Architect Name and Address	BAY LAKE, FLORIDA 32830
G.C Name and Address	
Project Name and Address

Scope Description	AREA	GROUP	SERIES
			COVER SHEET

Drawn By	Date
HD	09/27/19
Project #	Submittal #
3403	01
Drawing #	
00CS

3 ELEVATION - DINING ROOM 103
SCALE: 1/2"=1'-0" ARCH REF: A7/A-321

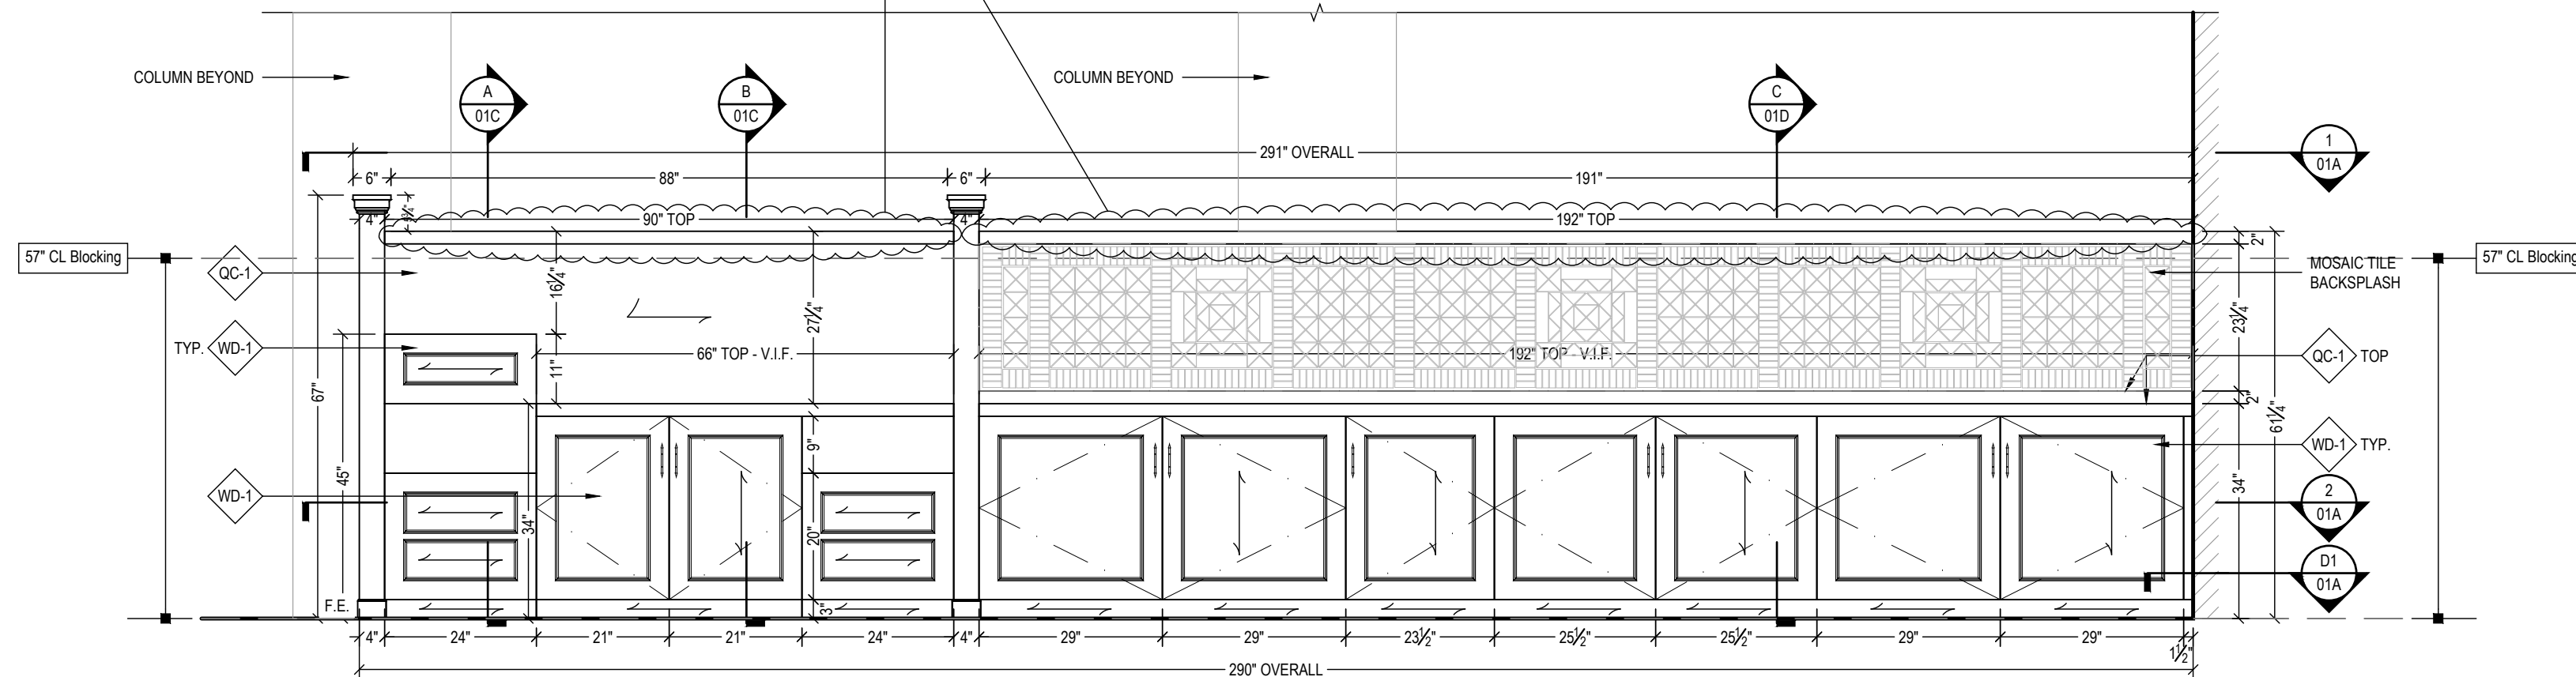
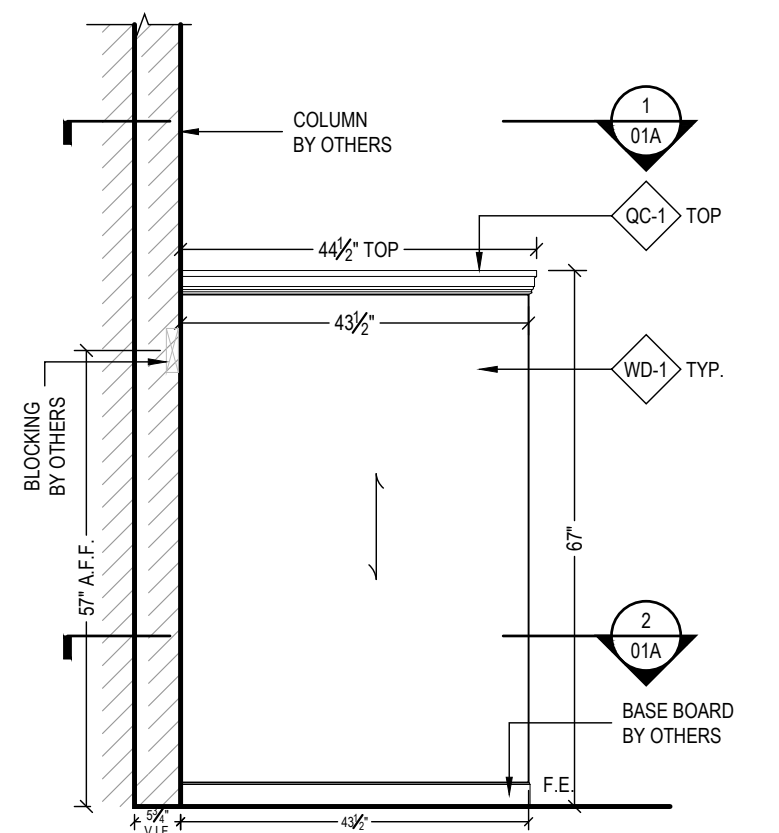
NOTE TO ARCHITECT:
THE 2 WOOD SHELVES BEYOND ARE SHOWN ALIGNED ON ARCH.
ELEVATION A7/A-321. ARCH. SECTIONS ARE NOT CONSISTENT
WITH ELEVATION. DRAWN TO MATCH ELEVATION.

A SECTION
SCALE: 1-1/2"=1'-0" ARCH REF: B6/A-602

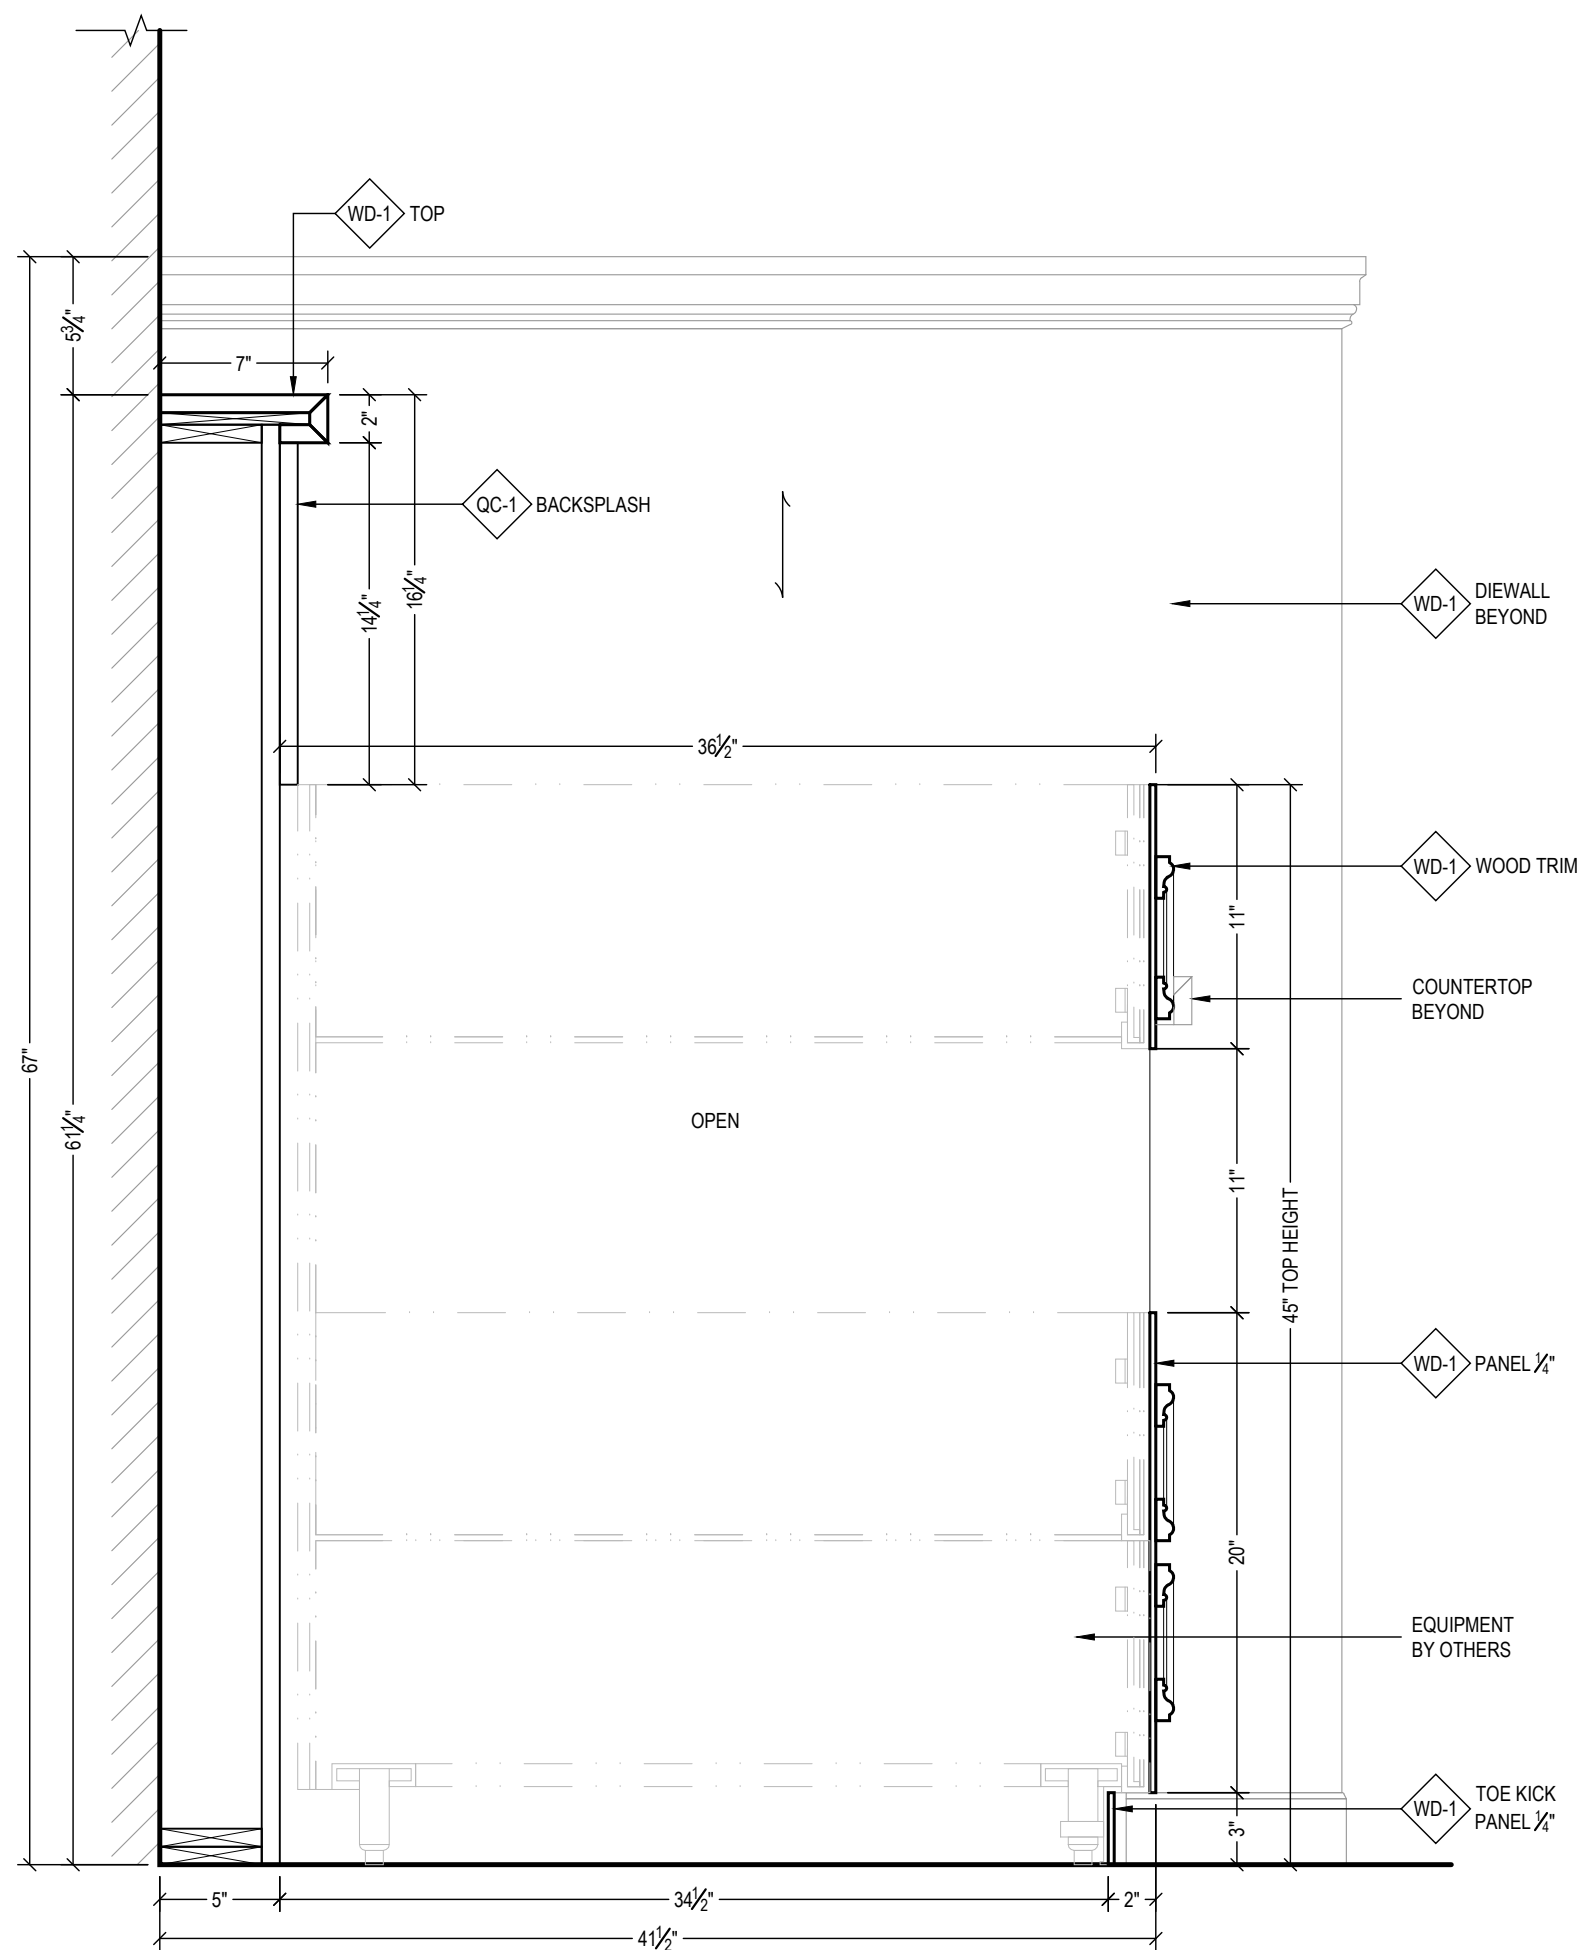
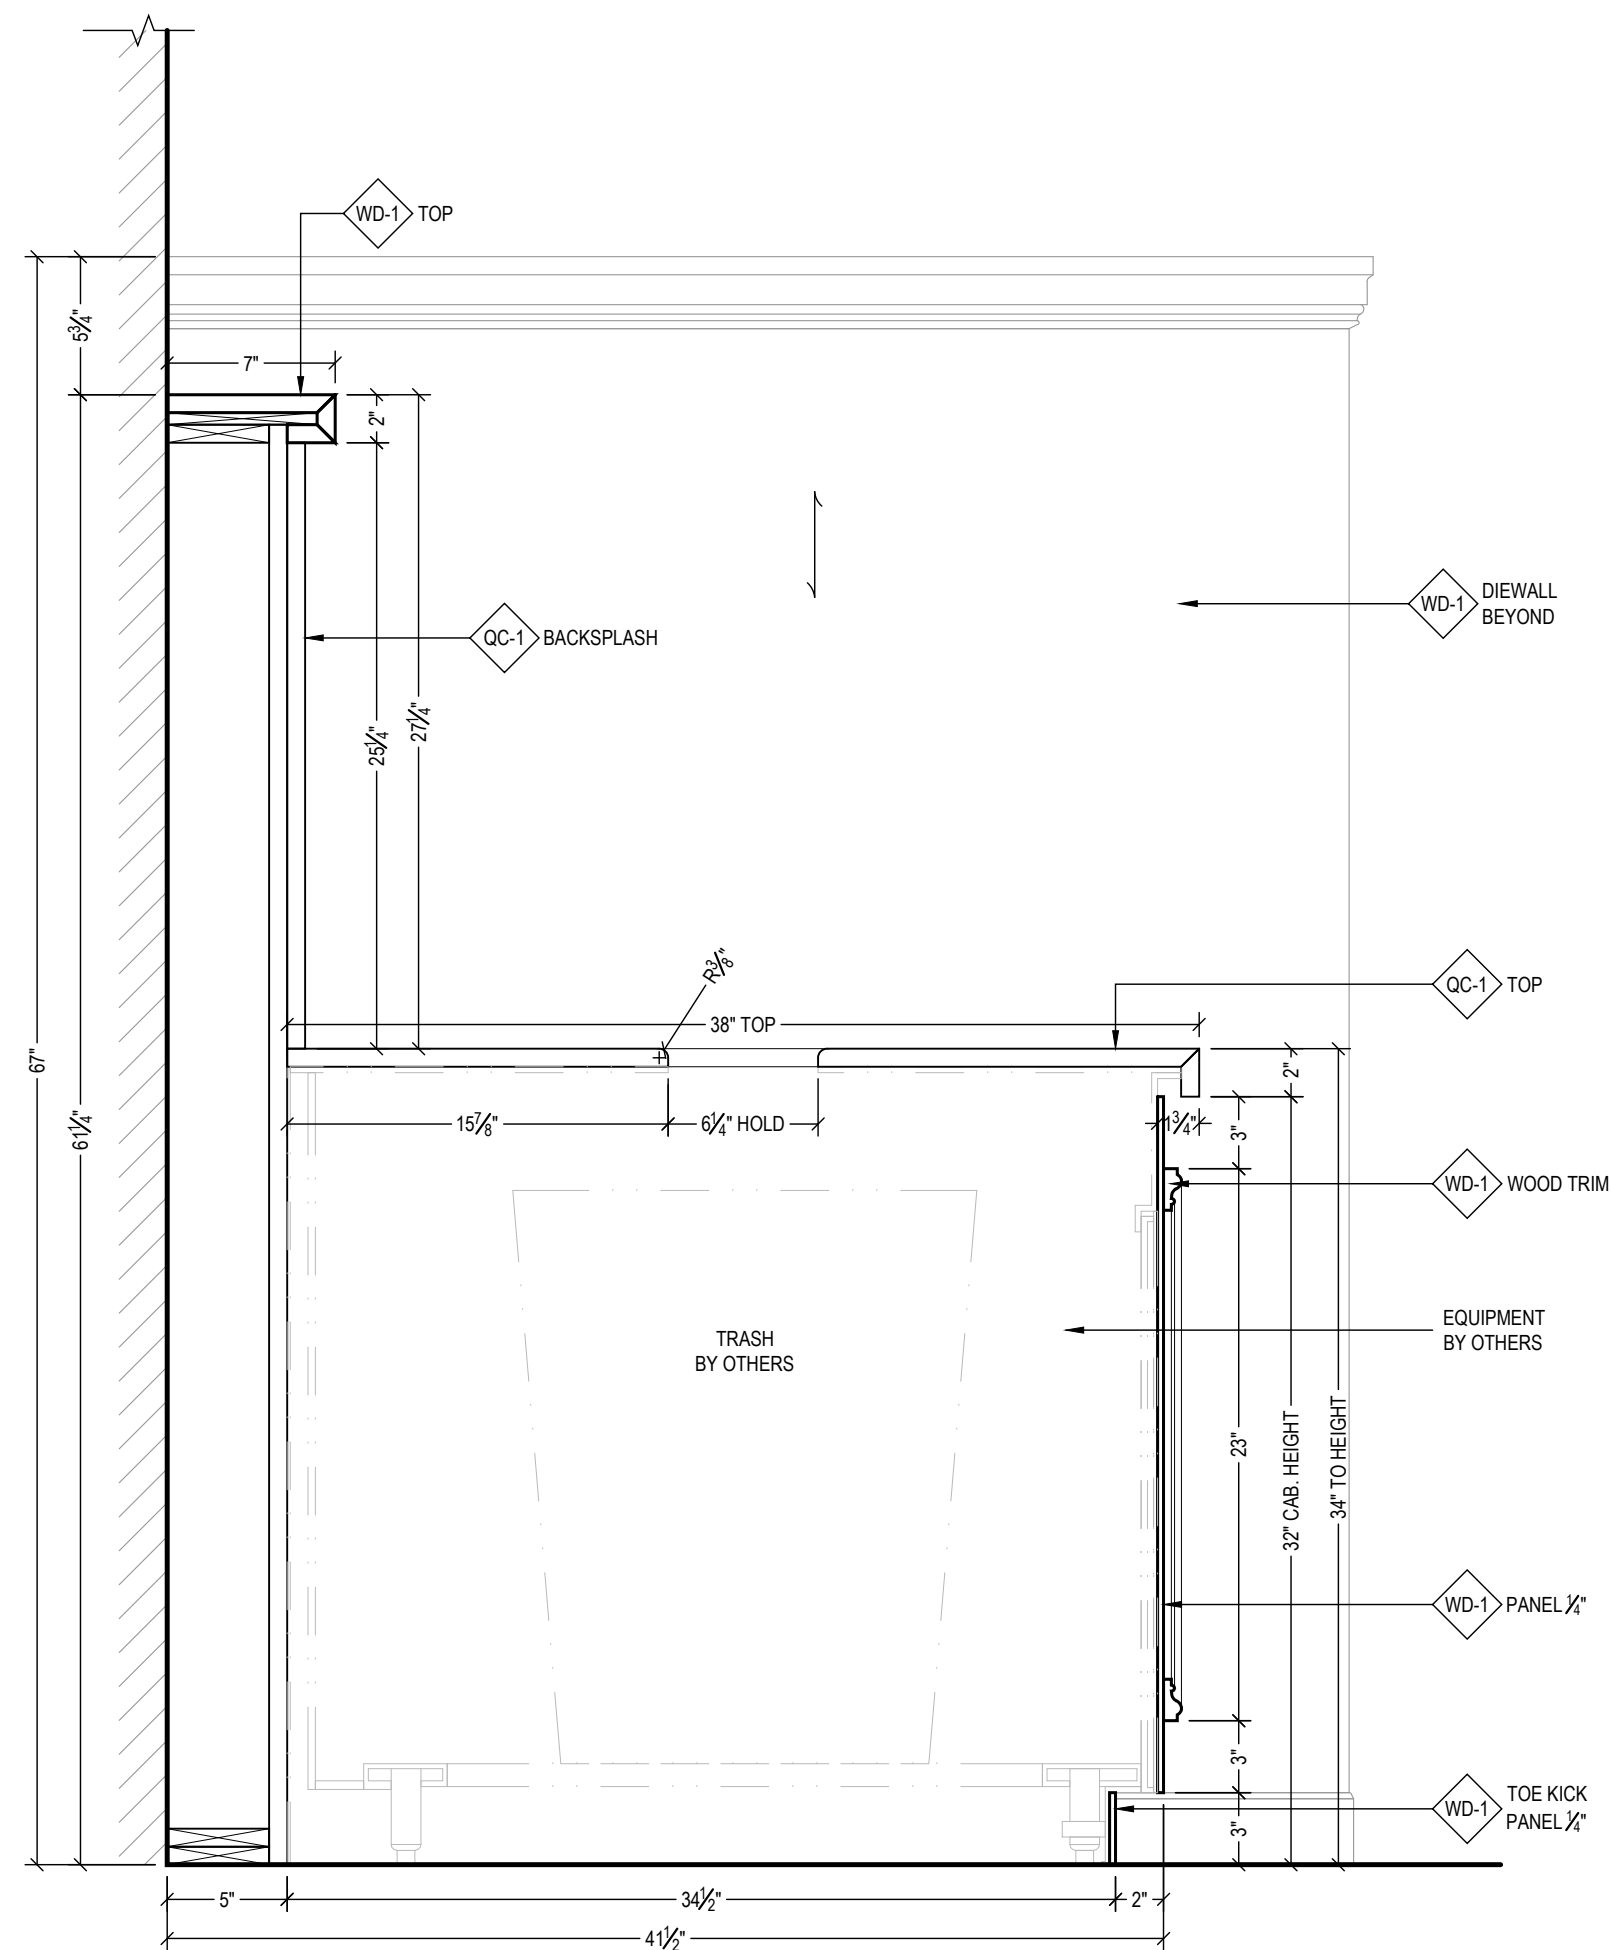
NOTE TO ARCHITECT:
PLEASE VERIFY AND CONFIRM
GRAIN DIRECTION IS AS SHOWN.

3 ELEVATION - DINING ROOM 103
SCALE: 3/4"=1'-0" ARCH REF: C8/A-321

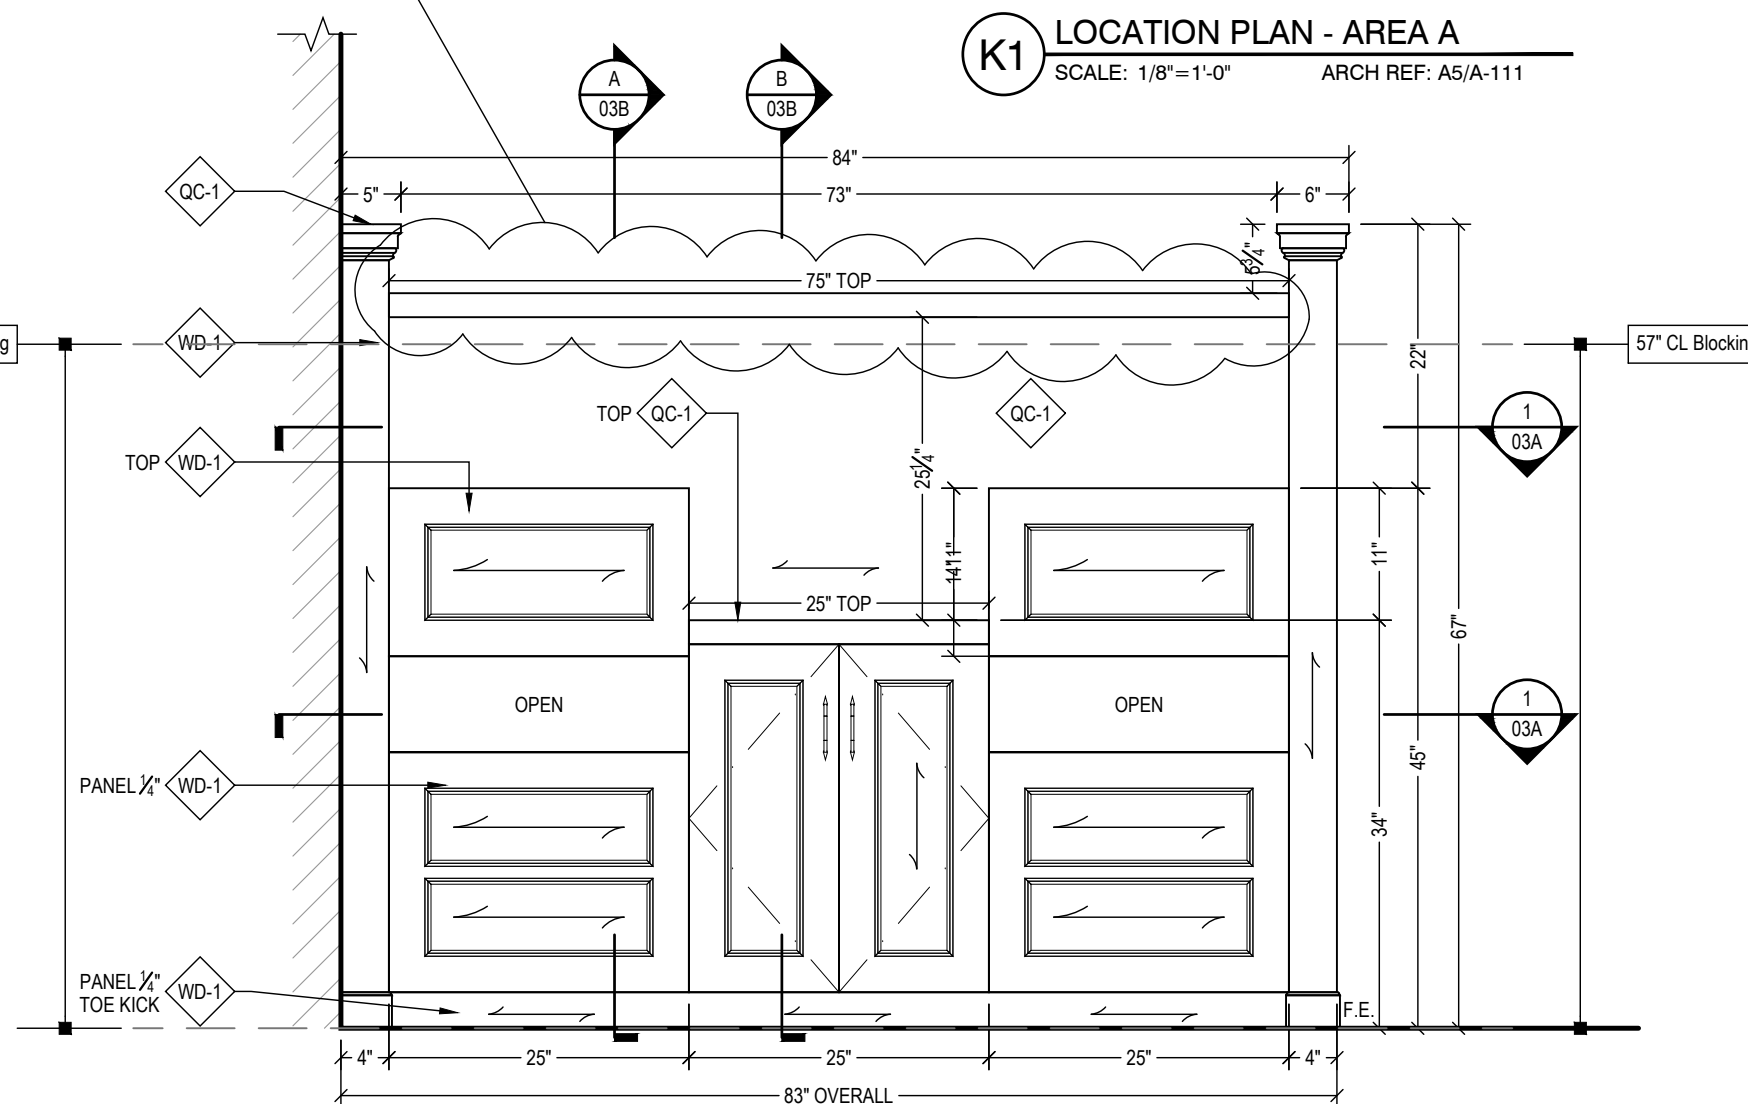
NOTE TO ARCHITECT:
HEIGHT OF WOOD SHELF BEYOND NOT CONSISTENT
BETWEEN ARCH. ELEVATION AND SECTION. DRAWN TO
MATCH HEIGHT OF UNIT ON PAGE 01A. PLEASE VERIFY.
